RETREAT AT PRAIRIERIDGE FILING NO. 1

CONSTRUCTION PLANS

FEBRUARY 2025

ROUNDABOUT NORTHEAST
FLOWLINE PROFILE

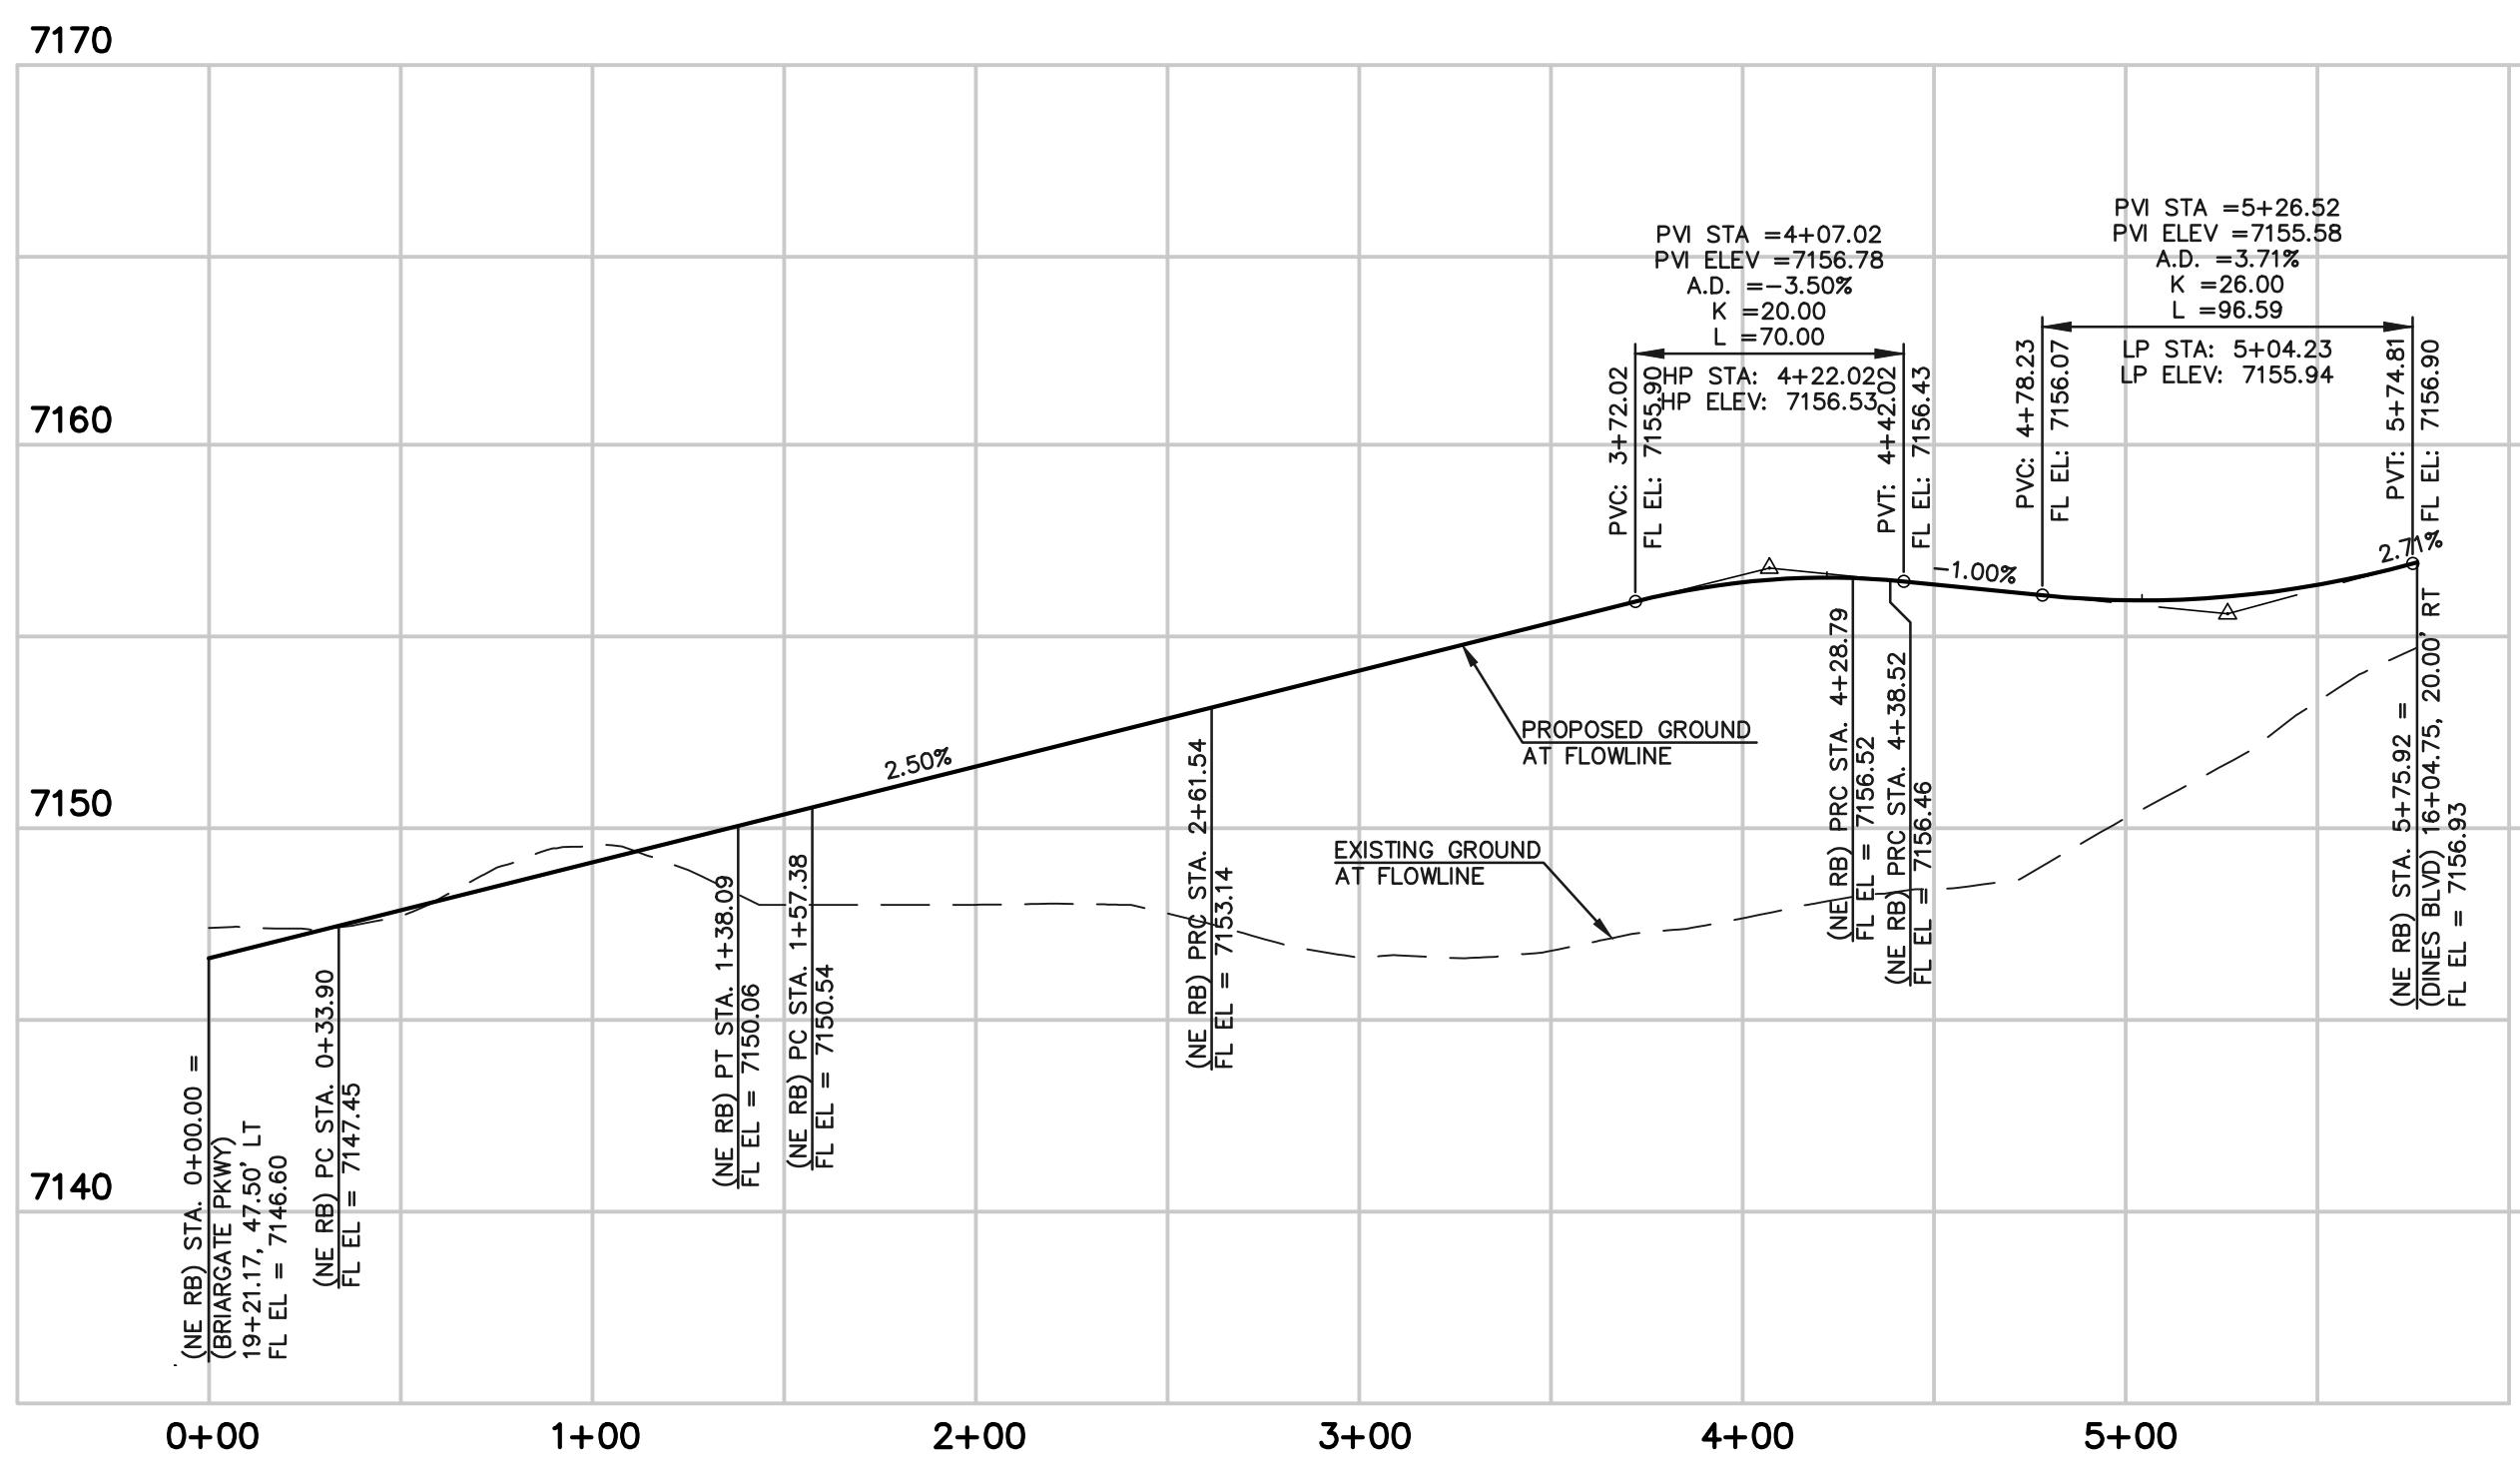
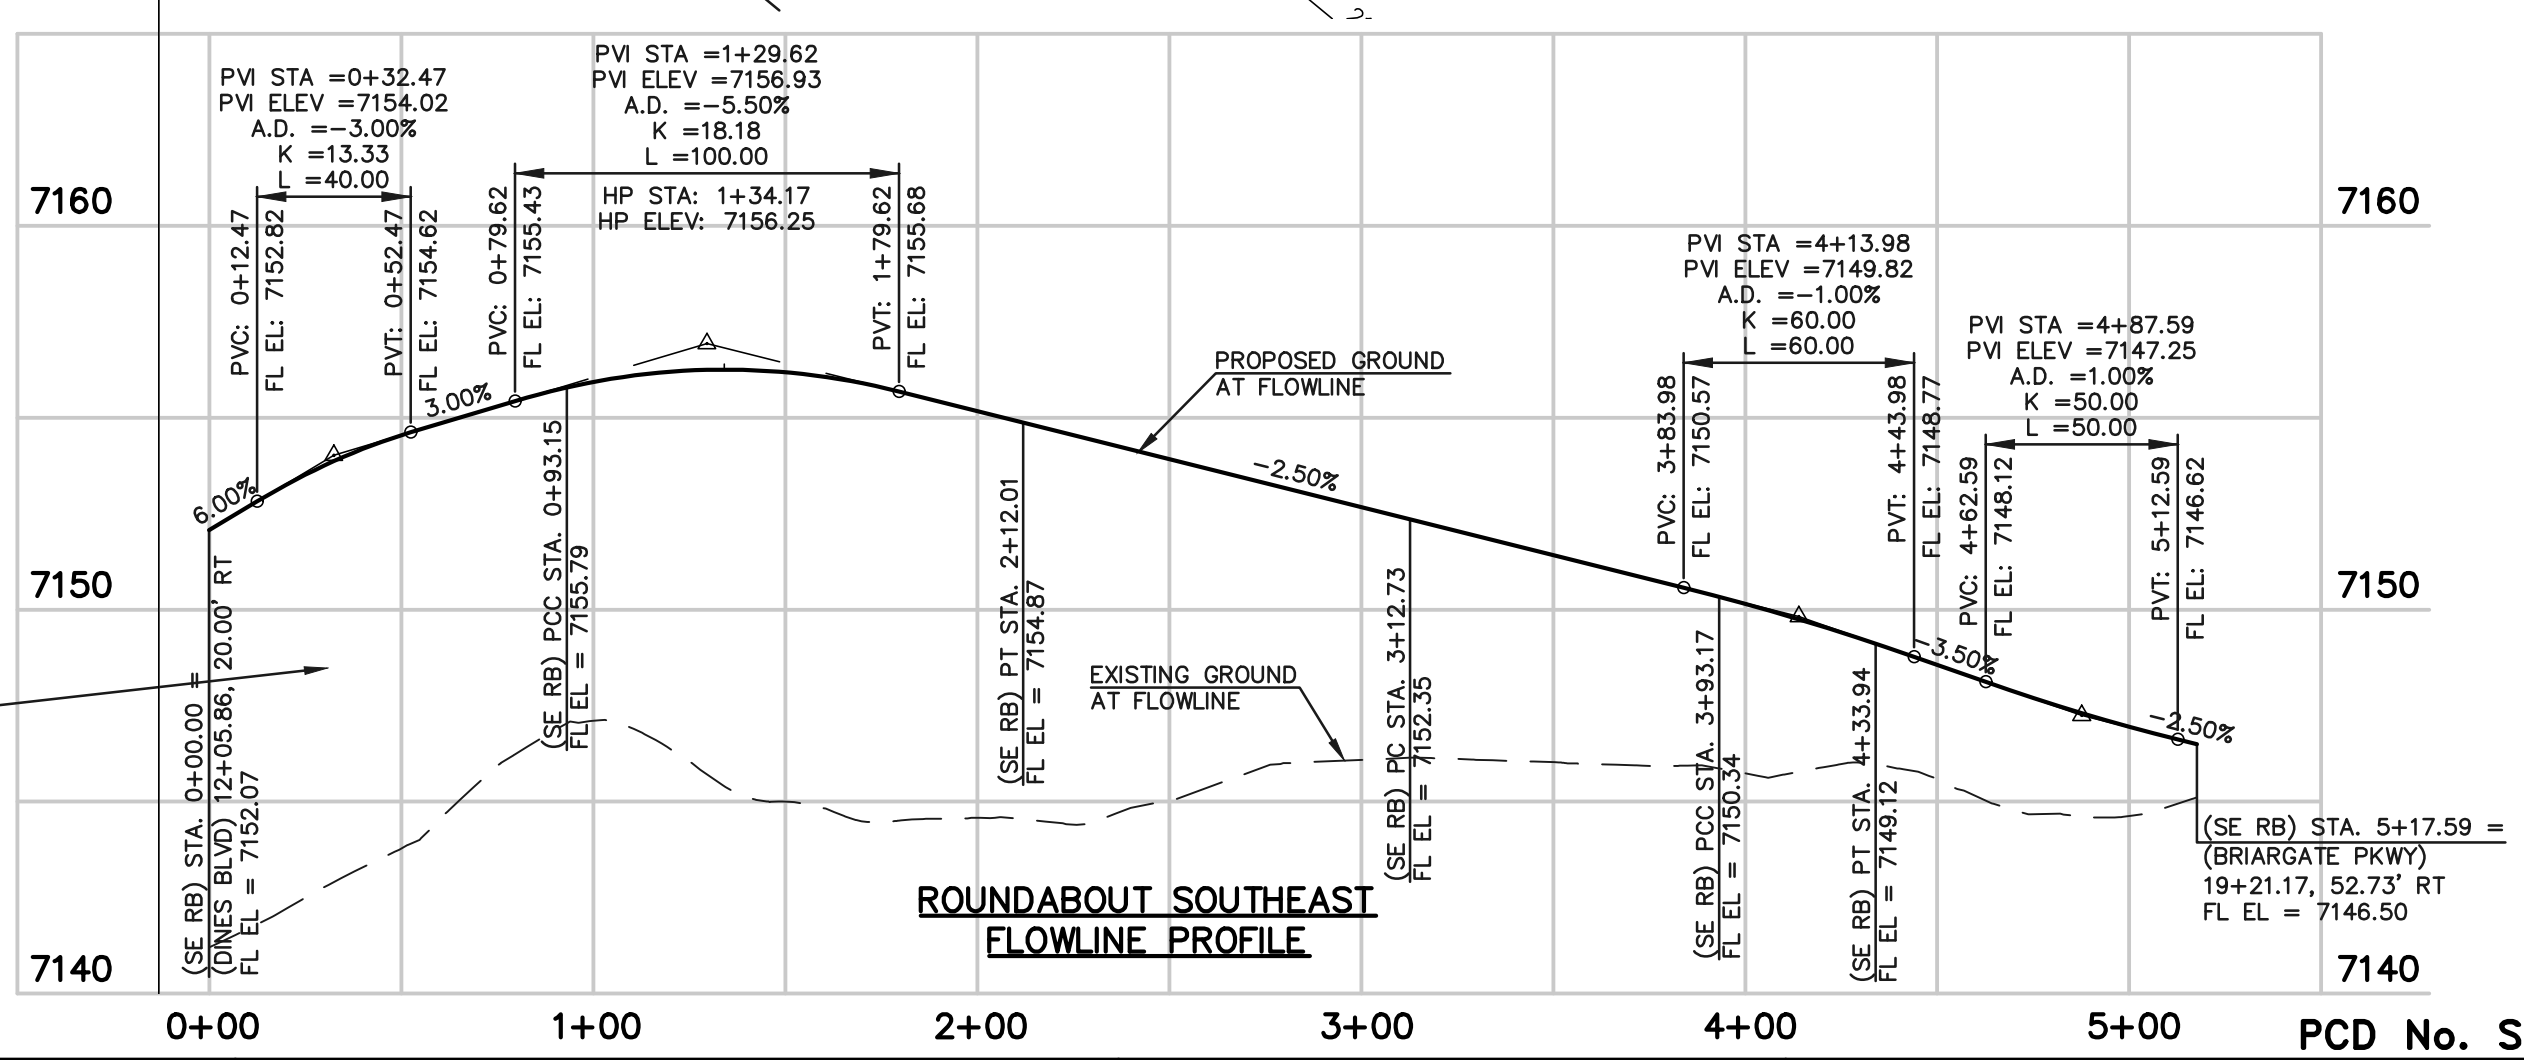
Detailed review to be provided once the roundabout design report has been submitted.

RETREAT AT PRAIRIERIDGE FILING NO. 1
CONSTRUCTION PLANS
PUBLIC STREET IMPROVEMENT PLAN
BRIARGATE PARKWAY SIGNAGE AND STRIPING

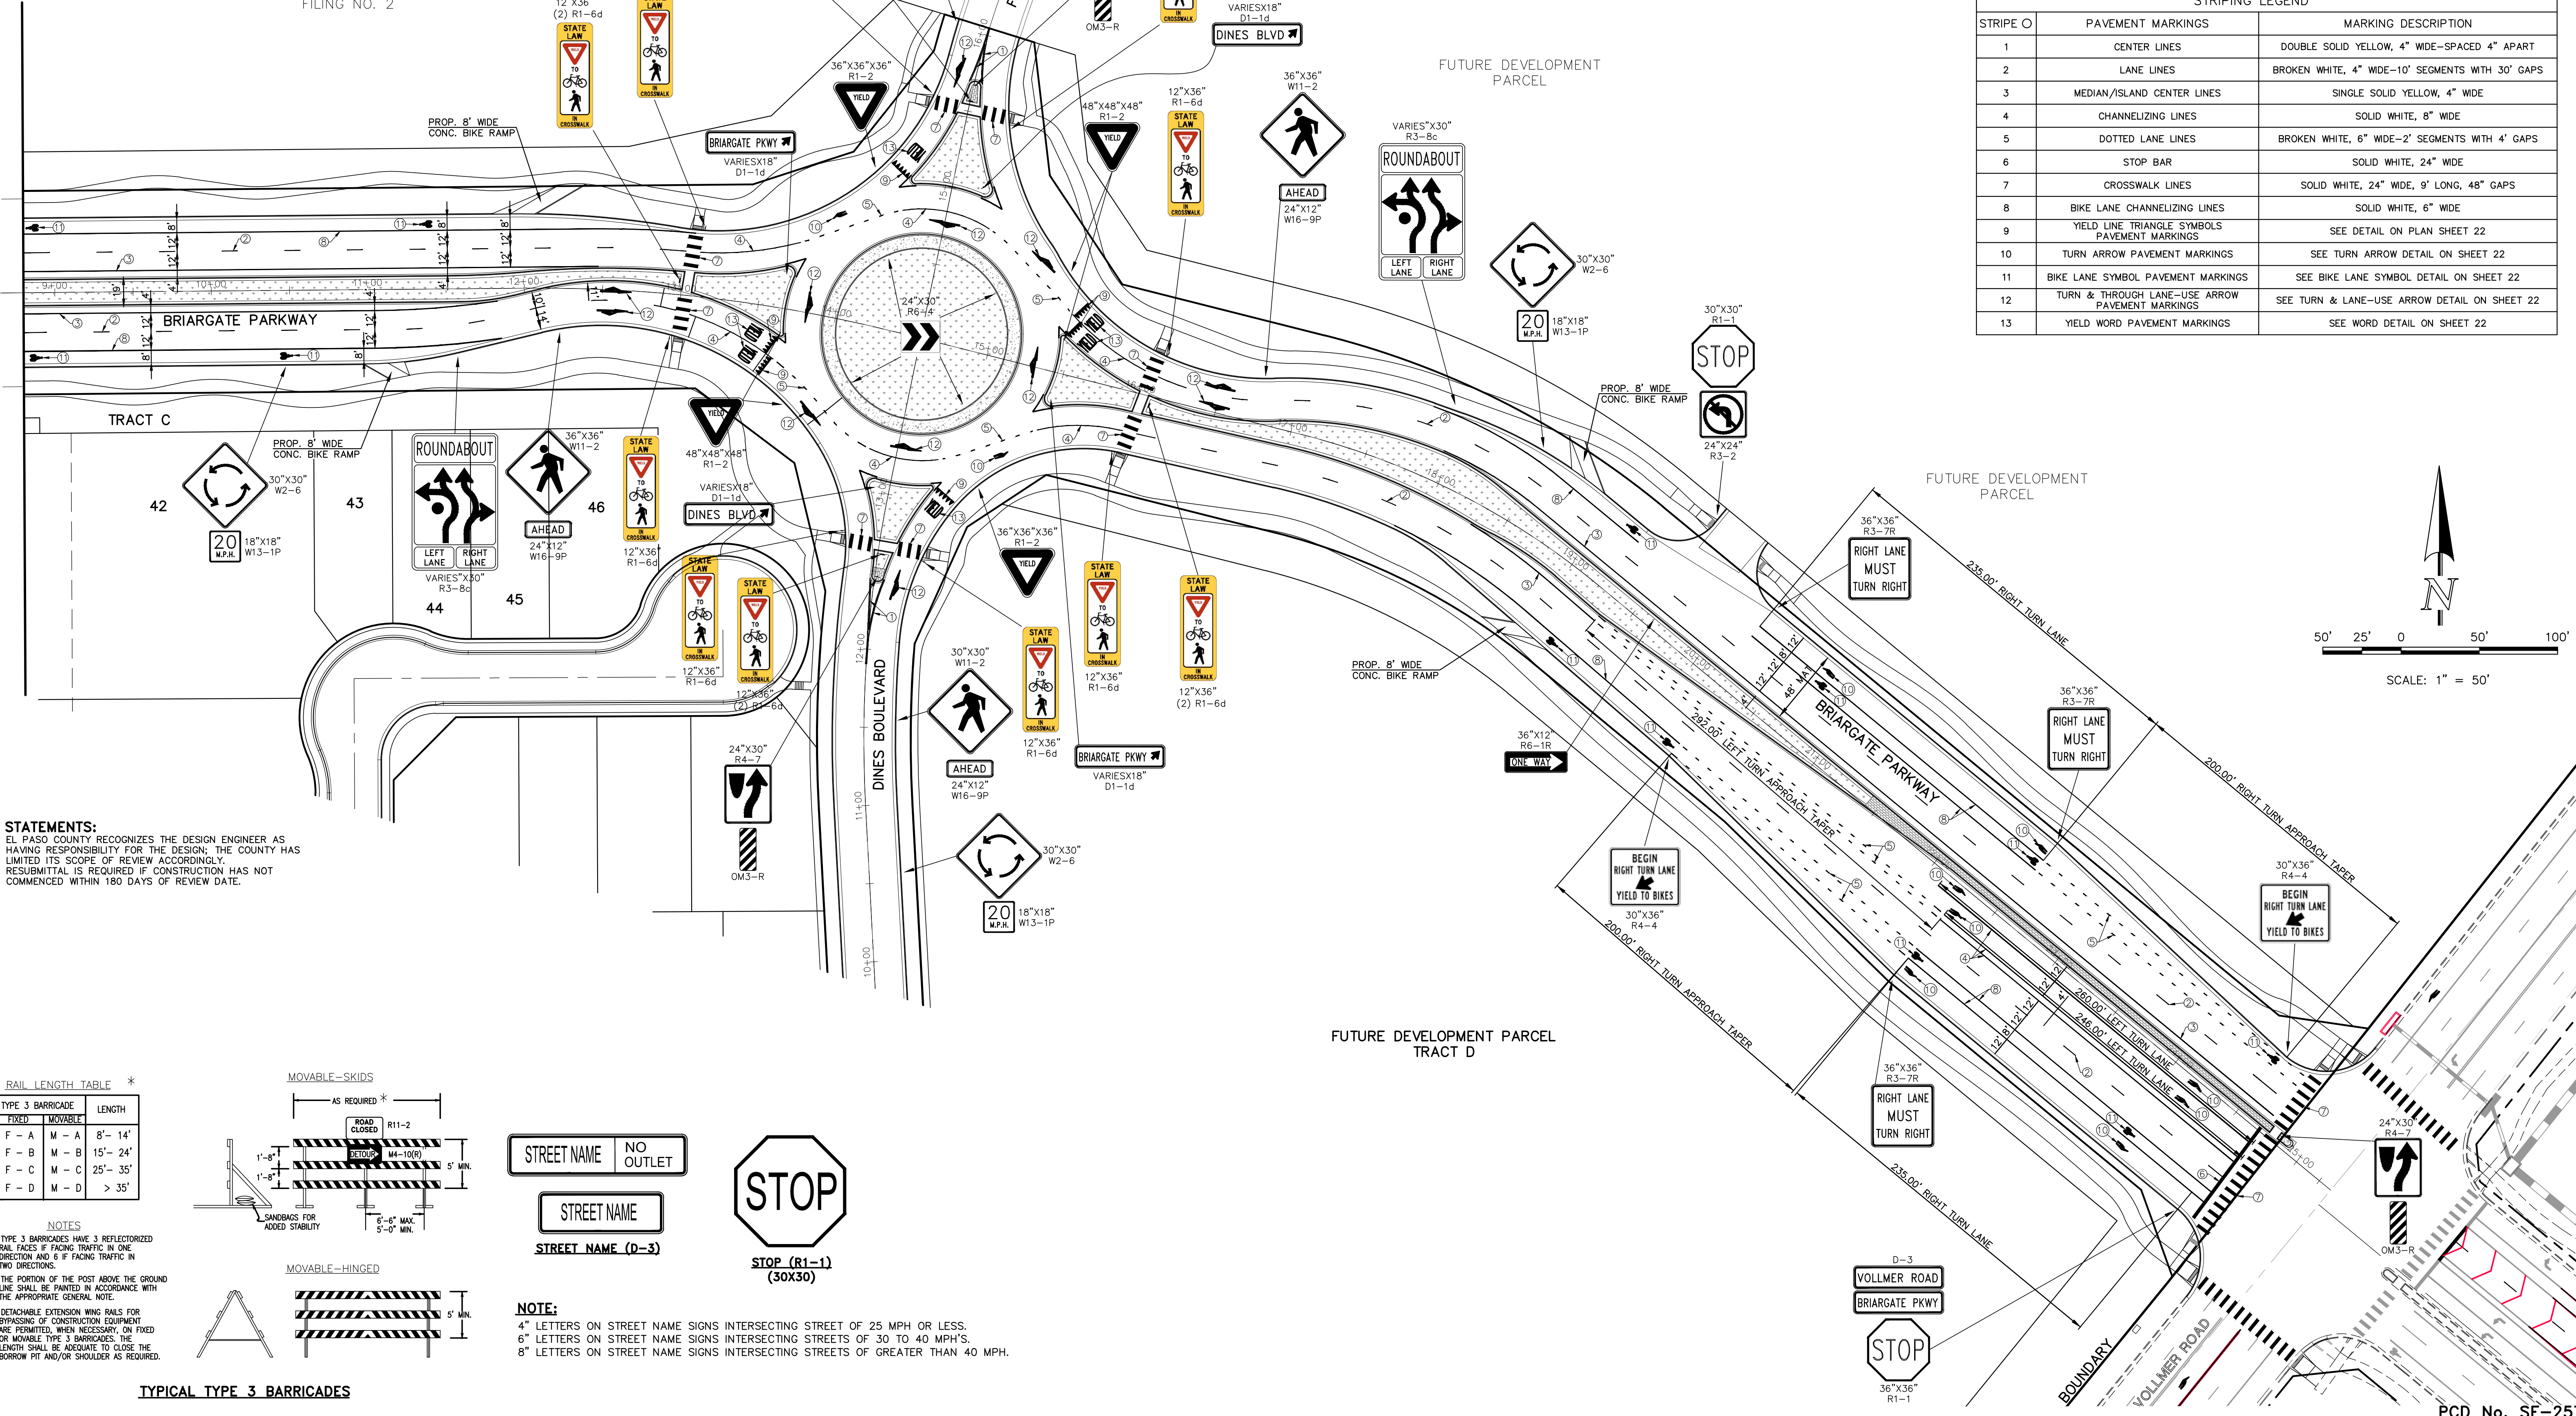
Detailed review to be provided once the roundabout design report has been submitted.
